**EXHIBIT NO. 1  
APPLICATION NO.  
A-6-PSD-09-43  
Land Use Map**

EXHIBIT NO. 2
APPLICATION NO.
<b>A-6-PSD-09-43</b>
Figure 5.3 of NEVP
Incorp'd by Ref. Into PMP
California Coastal Commission

Location Map: NEVP Phase 1 Coastal Access Features Project

**Project:** North Embarcadero Visionary Plan, Phase 1 Coastal Access Features Project  
**Location:** North Harbor Drive between Ash Street and F Street and West Broadway from North Harbor Drive to Pacific Highway, San Diego, California.  
**Date:** July 8, 2009

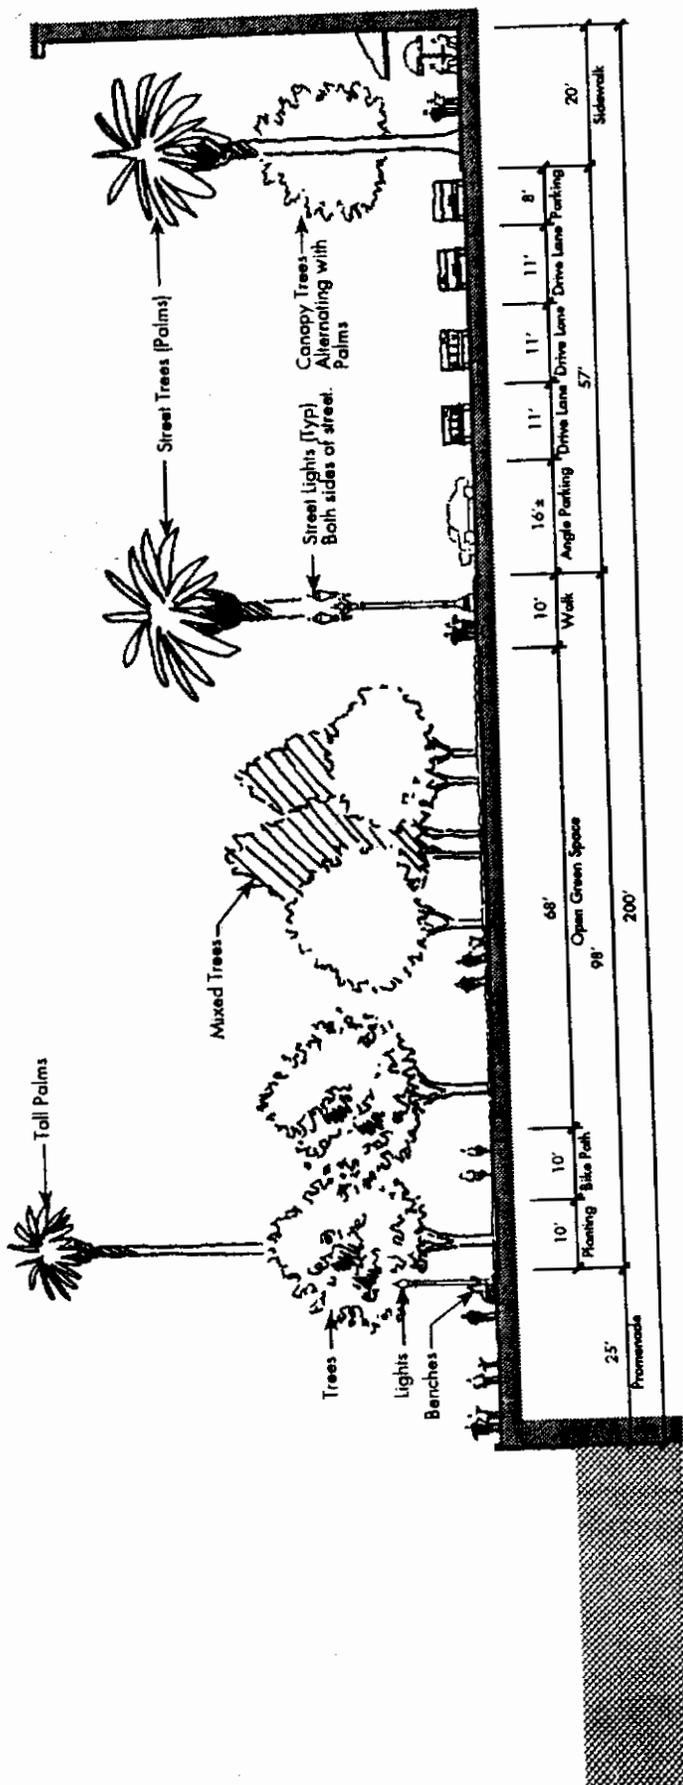
Figure 11 of the PMP graphically demonstrates Harbor Drive curving at West Broadway Street to accommodate an oval-shaped park at the foot of Broadway Pier. Port staff have estimated that this park would be approximately 79,200 sq.ft. in size, (including some amount of area that would be necessary to allow access to the pier from Harbor Drive), with another 24,300 sq.ft. potentially needing to be located in a new over-water structure. In its place, an approximately 16,000 sq.ft. rectangular plaza/pier entrance is proposed, along with 63,000 sq.ft. of esplanade on either side of the plaza, and approximately

The NEVP Improvements Phase I, if constructed as approved in the Port CDP, would preclude the construction of Broadway Plaza Landing Park in the configuration shown in the certified PMP. Figure 11 of the PMP graphically demonstrates Harbor Drive curving at West Broadway Street to accommodate an oval-shaped park at the foot of Broadway Pier. Port staff have estimated that this park would be approximately 79,200 sq.ft. in size, (including some amount of area that would be necessary to allow access to the pier from Harbor Drive), with another 24,300 sq.ft. potentially needing to be located in a new over-water structure. The esplanade is shown continuing on either side of the park.

**PMP Page 61:** Figure 11 shows 10-acre Broadway Landing Park fanning out at the end of Broadway Street into the Lane Field and Navy Broadway parcels. The **Figure 11** schematic also clearly shows the first two thirds of Broadway Pier also designated as "Park/Plaza".

The oval depicted on Figure 11 is not a specific project design, but rather a conceptual, illustrative, designation of land uses within the Phase 1 Project area. Translating the oval land use designation into an oval park plaza design would have required the District to acquire Navy property (southeast corner of Broadway/North Harbor Drive intersection) and remove existing Navy buildings, renegotiate the Lane Field lease, amend the California Coastal Commission Coastal Development Permit issued for Lane Field (northeast side of Broadway/North Harbor Drive intersection), and cause hitherto unevaluated impacts of constructing new wharf area over currently un-shaded waters of the Bay. Because the geometry cannot be achieved in half all of these precursors would be necessary to implement an oval.

The District redesigned the rectangular plaza at the foot of Broadway in a manner that maintains the same level of park plaza land use area available to the public as that discussed in the PMP. This is achieved with setbacks along West Broadway that the developers on the north and south sides will implement. The reconfiguration results in the scenic North Harbor Drive having an alignment within the oval depicted on Figure 11

The text of the PMP does not require an oval configuration, nor does the description of the Proposed Project found in the project list specify that the park shall be oval. Moreover, Figure 11 of the Precise Plan depicts only land uses and is illustrative; it does not depict engineering or architectural designs. That level of detail goes beyond what is typically required in such a plan. The PMP (page 1) clearly states that precise plans such as those depicted on Figure 11 are "...maps pertaining to subareas of the bay illustrating Land and Water Use allocations that are planned for each area." While the name "precise plans" infers greater detail than a general plan, the PMP itself limits that detail to the identification of general land and water uses only. No reference is made to, nor does the PMP require that, the Proposed Project design reflect the shape of the land use designations depicted in illustrations such as Figure 11 and no specifics regarding size are provided. The plaza included in the Project will be part of a larger civic space (referred to as Broadway Hall) that includes park plaza areas on the Broadway Pier, Navy property, and Lane Field leasehold that will be capable of accommodating large scale public events and celebrations including festivals and parades.

**Figure 5.3**  
Section of Bayfront Esplanade

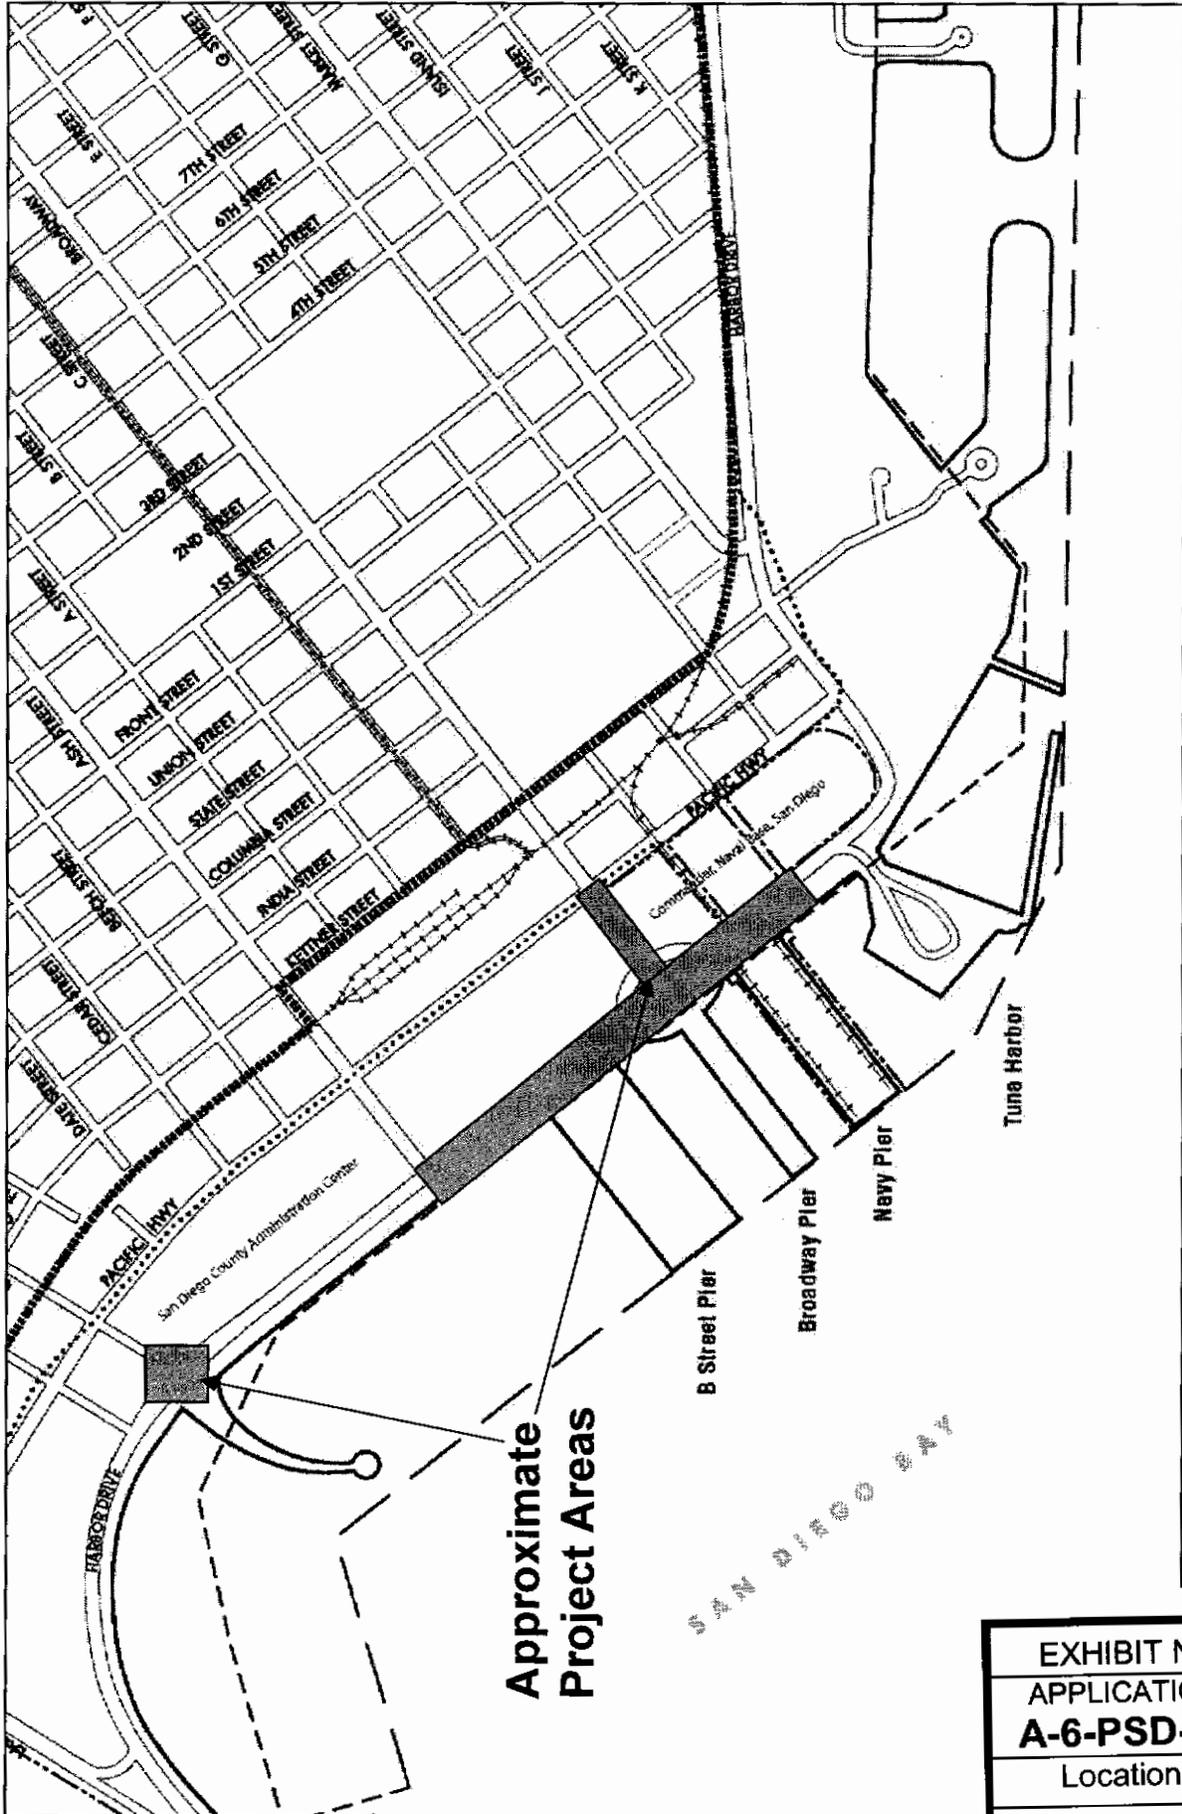
The certified PMP also incorporates by reference Figure 5.3 of the NEVP. Once a policy, figure, or project is inserted into the PMP, it is no longer guidance, but the standard of review. The configuration of the proposed esplanade is significantly different than the one in Figure 5.3. Perhaps most significantly, a 10-foot wide designated bike path has been combined with the pedestrian walkway to make a 29-foot wide multi-use promenade. Port staff have indicated that local bicycle organizations have expressed a preference for Pacific Highway as the primary, designated north-south bikeway in the Embarcadero. Commission staff agree with the intent of the revised plan to still accommodate bicycles on the Esplanade, but in other areas, we have seen significant conflicts between bicycles and pedestrians on shared-use paths. Again, the shifting of the primary bicycle route to Pacific Highway and the joint accommodation of bicyclists and pedestrians on one path, should be reflected in a broader PMP-level analysis of interests and priorities for public access along the shoreline that goes beyond the scope of this one permit.

The certified PMP incorporates by reference a specific Figure 5.3 on the NEVP which is a cross-section of the esplanade and identifies the design, minimum width and location of the specific public access features along the North Embarcadero. Figure 5.3 identifies specific widths of the esplanade, promenade and bike path. The CDP has approved an alternative configuration including combining the bike path with the pedestrian walkway as a multi-use promenade. As approved, the revised configuration for the access improvements may be acceptable, but it is not consistent with the PMP as certified.

However, Figure 3 of the EIR addendum shows a cross-section of North Harbor Drive that is significantly different than Figure 5.3. For example, the promenade is 29, not 25 feet wide; the bike path has been relocated next to Harbor Drive and has been reduced from 10 to 9 feet wide; the width of the esplanade from the inland curb of Harbor Drive to the western extent of the seawall would be 105.5 feet rather than 123 feet; the sidewalk on the inland side of Harbor Drive would be 15.5 feet wide instead of 20 feet wide.

The referenced Figure 5.3 of the NEVP is an illustrative plan that shows a representative cross section from an undefined point along the envisioned approximately 1.5 mile long esplanade and roadway along North Harbor Drive. The cross section is typical, not prescriptive, and it could not be prescriptive because the actual width of the esplanade and right-of-way varies at different sections of the esplanade and right-of-way, such as where structures would exist, where access to piers is necessary, etc. The text of the PMP deliberately establishes the minimum for the breadth of the esplanade (no less than 100 feet) in recognition of the substantial length of esplanade and the diversity of hardscape and softscape elements conceived. The cross section merely establishes representative project elements, a suggested order to those elements, and the general aesthetic intent of the esplanade and roadway as envisioned. As described, the Project includes all of the elements shown within the cross section, in order, and refines, while remaining consistent with, the general aesthetic intent.

The Figure 5.3 referenced is itself described in the NEVP as a 'typical' cross section from an undefined point along the envisioned approximately 1.5 mile long esplanade and roadway along North Harbor Drive. The cross section is typical, not prescriptive, and it could not be prescriptive because the actual width of the esplanade and right-of-way varies at different sections of the esplanade and right-of-way, such as where structures would exist, where access to piers is necessary, etc. The NEVP is not a prescriptive plan; rather a concept plan as stated on page 1 of the NEVP: "The purpose of the Plan is to establish a concept for public improvements, and strategies to finance them, befitting the setting and regional significance of the area, and to guide private development in a way that optimizes property values and reinforces the public realm." Port staff agrees with Coastal staff comment b, that consistency with the NEVP is not at issue. Subsequently Port staff does not agree with this comment.

The differences described do not change the use of any component of the project compared to the Port Master Plan or Master EIR and are viewed as a refinement of the concepts in the NEVP that reflect practical implementation of the vision. Page viii of the Addendum states "The Port has developed more detailed site plans and elevations for the North Embarcadero in order to implement the concepts identified in the NEVP. These subsequent plans involve additional detail and reconfiguration of features from that shown in Figure 3.3-1 of the Master EIR. " The changes outlined by California Coastal Commission staff are minor in nature, no alteration in use is described and the District disclosed that the project is a refinement of the concepts of the visionary plan as referred to in the Port Master Plan. The commenter does not provide substantial evidence that a Port Master Plan is necessary. The District takes this opportunity to clarify that the Proposed Project does not result in any changes to existing land use designations within the Port Master Plan and achieves the specifics identified in the Port Master Plan text for this area (Port Master Plan page 63). A consistency evaluation regarding the Proposed Project's consistency with the Port master Plan and the Coastal Act has been provided to the commenter and will be included in the information provided to the Board of Port Commissioners as part of the decision making process for issuance of a Coastal Development Permit for the project.

Exhibit CCC-1 Existing Conditions and the Proposed Project

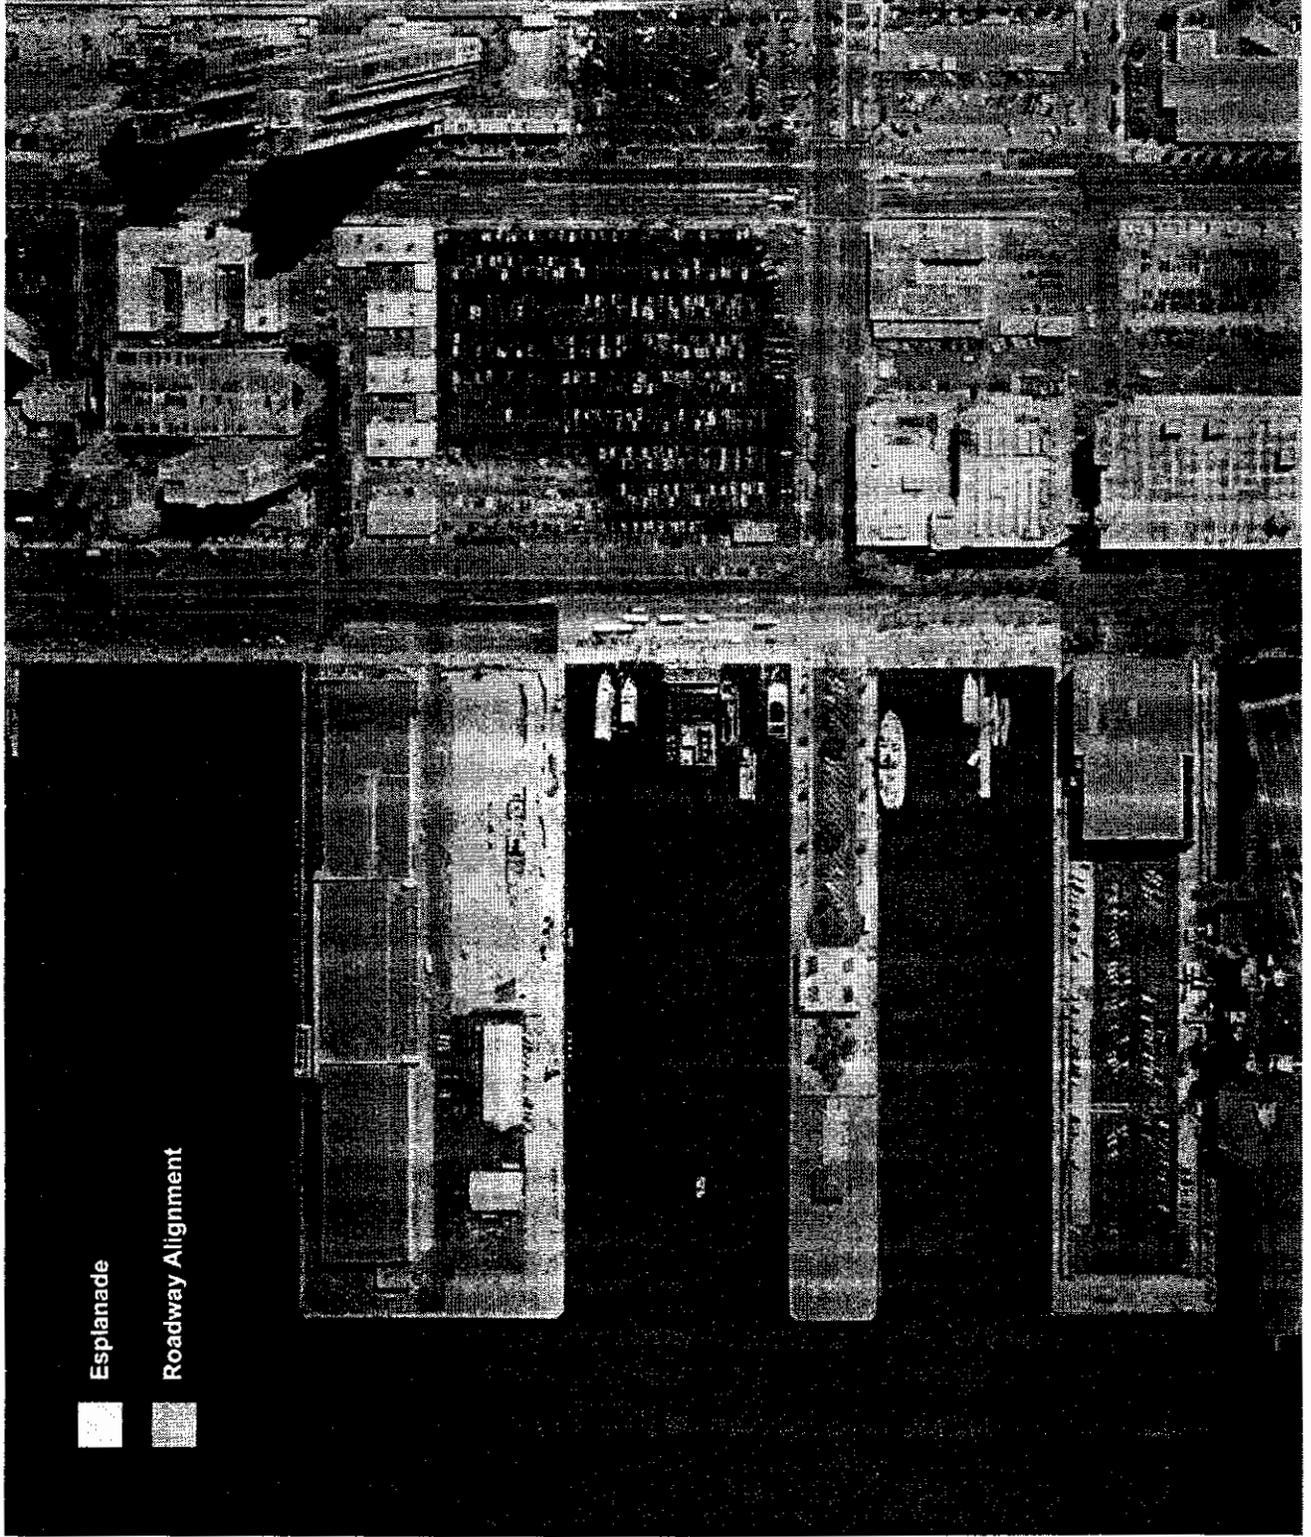
**CCC.2. The Commenter identifies differences in details between Figure 3 of the Initial Study/Addendum for the Proposed Project and the NEVP Figure 5.3.** This comment does not address the adequacy of the Addendum/ Initial Study evaluation of whether the Proposed Project would result in a project-specific additional significant impact not evaluated in the Master EIR for the NEVP. The differences are in detail only (partly driven by the need to maintain four lanes for traffic until all of North Harbor Drive is realigned and B Street is opened through from Pacific Highway) and Figure 5.3 of the NEVP is an 'illustration'. The cycling component of the Esplanade is incorporated into the expanded promenade; page 5 of the Initial Study/Addendum states "a continuous 30-foot wide bayfront promenade adjacent to the Bay, for mixed pedestrian and bicycle use" and shown in Figure 3 of the Initial Study/Addendum. The 9-foot wide path adjacent to the road is not a bike path but rather a running/walking path as described on page 5 of the Initial Study /Addendum. The Port Master Plan, page 60, describes the Esplanade as, "a grand pedestrian-orientated esplanade (no less than 100-feet wide)". The Proposed Project achieves a 105-foot wide Esplanade While the sidewalk provided by the Proposed Project is not the full width described in the NEVP, the full width is achieved through additional area associated with the Lane Field and other developments providing for plaza/public use including seating for activating uses as depicted on Figure 5.3 of the NEVP. The comment does not raise an environmental issue or address the adequacy of the Addendum/Initial Study. Accordingly, no further response is required.

in the NEVP, including the Figure 5.3 referenced by the commenter, do not result in physical changes in the environment that may result in significant adverse impacts. Page viii of the Addendum states "The District has developed more detailed site plans and elevations for the North Embarcadero in order to implement the concepts identified in the NEVP. These proposed plans involve additional detail and reconfiguration of features from that shown in Figure 3.3-1 of the Master EIR. " The purpose of the Initial Study/Addendum is to determine whether or not the Proposed Project would result in the creation of any new significant impacts not previously identified in the NEVP Master EIR. In response to this comment the District has provided graphics to the commenter that depicts the existing conditions and the Proposed Project (Exhibit CCC-1 below).
